# BUSCONNECTS –C11 Kimmage to City Centre

## Accessibility Audit Report

Drawing Title: **ROUTE 11: KIMMAGE TO CITY CENTRE ACCESSIBILITY AUDIT**

**Crossing Kimmage RD W-Kimmage RD Lower**

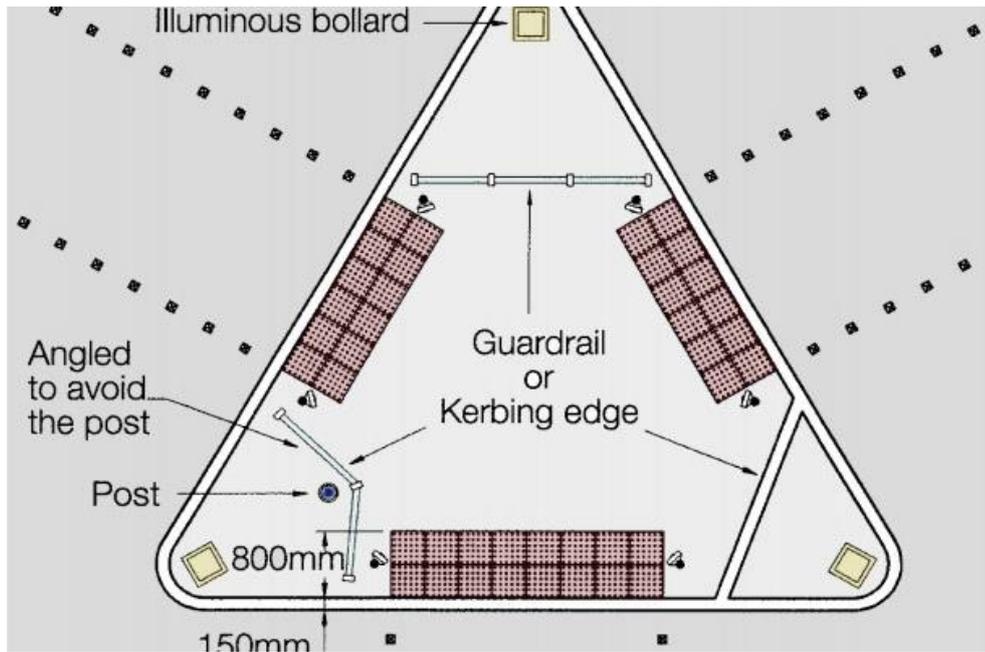
Refuge island and crossing points on footpath can be observed without proper kerb and absence of pedestrian guardrails.

Shortcomings: Refuge island that combines controlled crossing point and uncontrolled crossing without the correct tactile paving, lack of dropped kerb.

**Stairs in footpath at Clanbrassil Street Upper**

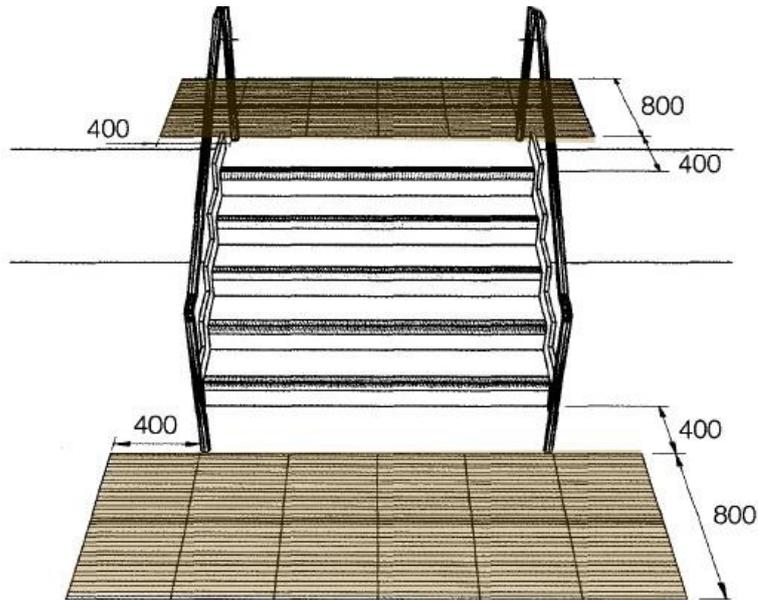
The access routes that approach to the Emmet bridge should be reviewed because in this area it is appreciated that certain slopes can be greater than 1:20 and therefore have to be considered as ramped access route and to comply with the accessibility regulations.

Recommendations: A corduroy tactile surface should be implemented to warn visually impaired people of the presence of steps. Follow the figure below

Sheet Number: 01 of 11  
 Status: S0  
 Rev: P01

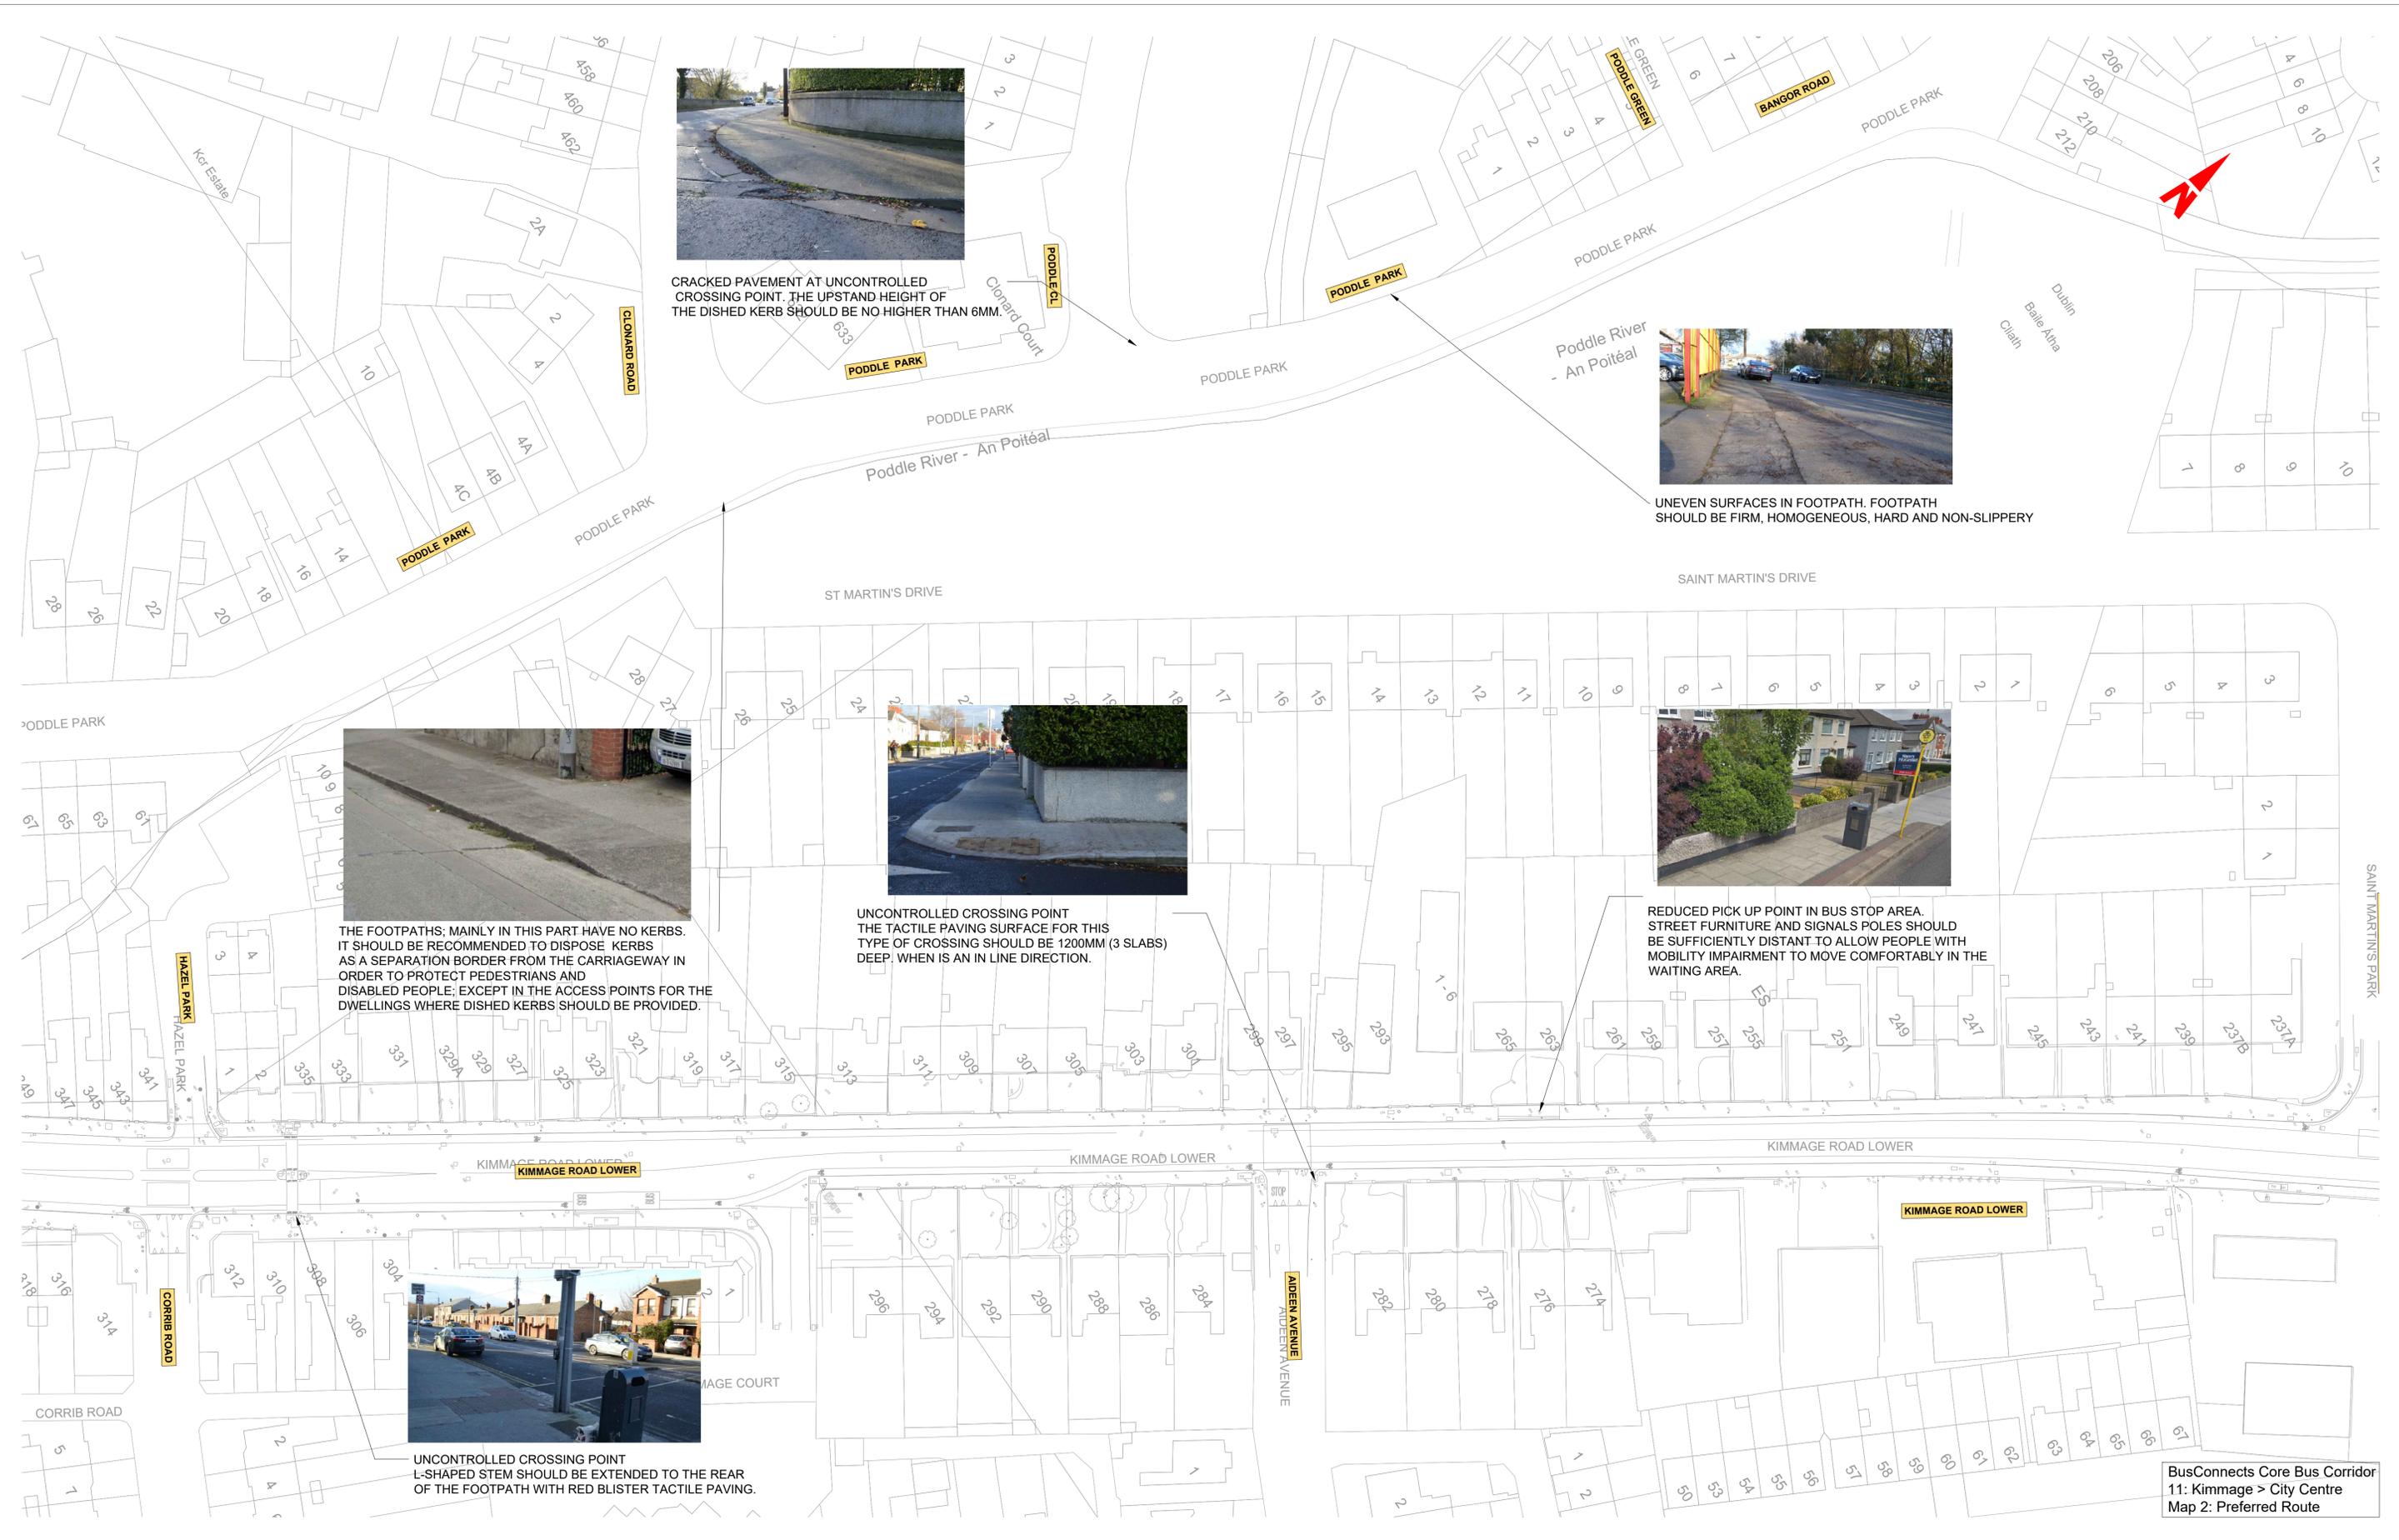
IN THE DESIGN PROJECT THIS BUS STOP IS MOVED CLOSE TO TERENCE ROAD WEST JUNCTION WHERE A BUS STOP ISLAND IS PROPOSED. IN ORDER TO AVOID THE CONFLICT OF PEDESTRIANS/CYCLISTS A ZEBRA CROSSING SHOULD BE RECOMMENDABLE TO PROVIDE AND DIFFERENT ACCESSIBILITY MEASURES.

REFUGE ISLAND. STAGGERED CROSSING POINT WITH NO TACTILE PAVING INCORPORATED. THIS TYPE OF CROSSING SHOULD BE REVISED IN ORDER TO AVOID DISABLED OR MOBILITY IMPAIRED PEOPLE TO GET STUCK.

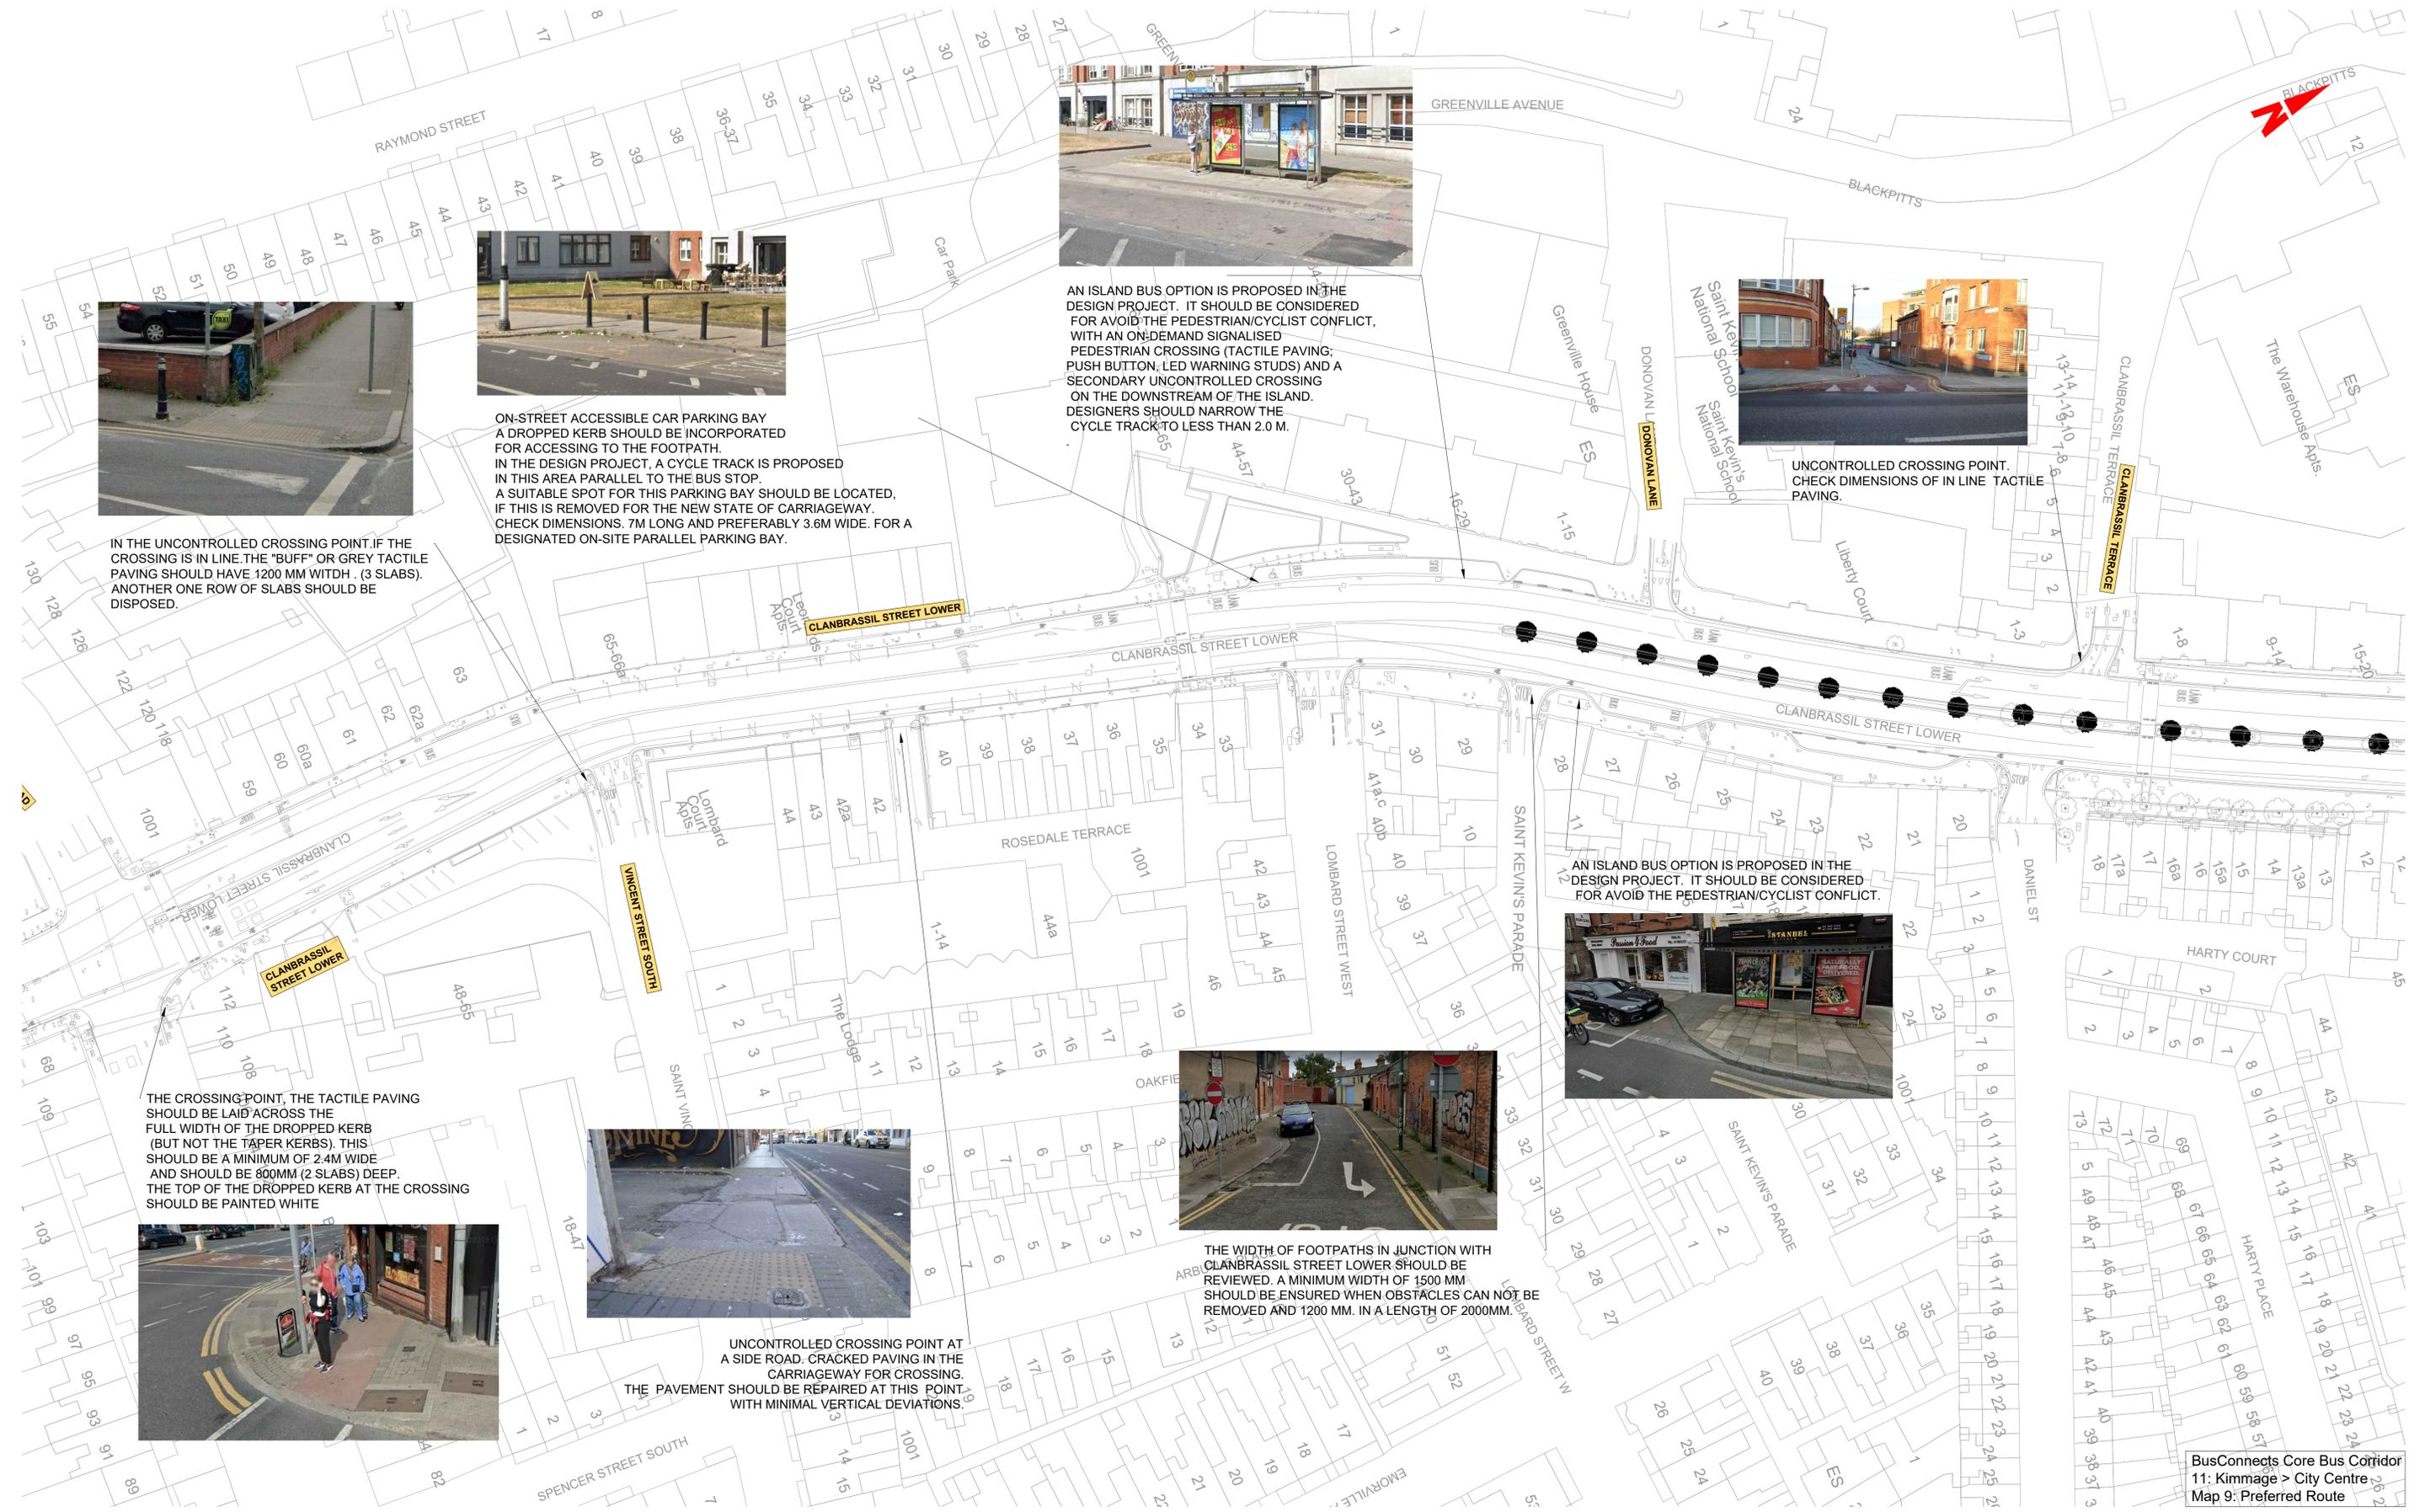
AN ISLAND BUS OPTION IS PROPOSED IN THE DESIGN PROJECT. IT SHOULD BE CONSIDERED FOR AVOID THE PEDESTRIAN/CYCLIST CONFLICT.

THE CROSSING POINT, THE TACTILE PAVING SHOULD BE LAID ACROSS THE FULL WIDTH OF THE DROPPED KERB (BUT NOT THE TAPER KERBS). THIS SHOULD BE A MINIMUM OF 2.4M WIDE AND SHOULD BE 800MM (2 SLABS) DEEP. THE TOP OF THE DROPPED KERB AT THE CROSSING SHOULD BE PAINTED WHITE

UNCONTROLLED CROSSING POINT AT A SIDE ROAD. CRACKED PAVING IN THE CARRIAGEWAY FOR CROSSING. THE PAVEMENT SHOULD BE REPAIRED AT THIS POINT WITH MINIMAL VERTICAL DEVIATIONS.
